**Control Number - 54335**

## Transmission System Constraints Decrease Generation Reliability

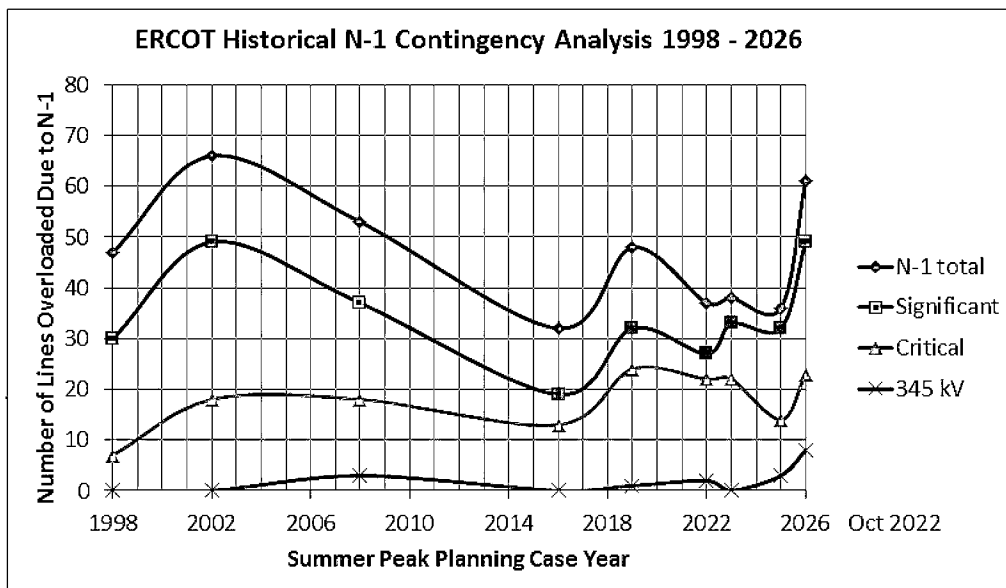
Two strong indicators for the decline in transmission adequacy are: 1) the number of GTCs<sup>1</sup> are rising, and 2) the number of N-1<sup>2</sup> overloads has an upward turn in the 2026 case dated Oct 2022 (see below).

**2) N-1** analysis means testing all single line outages for causing other lines to overload. If lines start tripping out on overload, the worst case scenario is a blackout the entire system. The above graph shows numbers of N-1 line overloads each year. Look for localized red areas on the real time map.
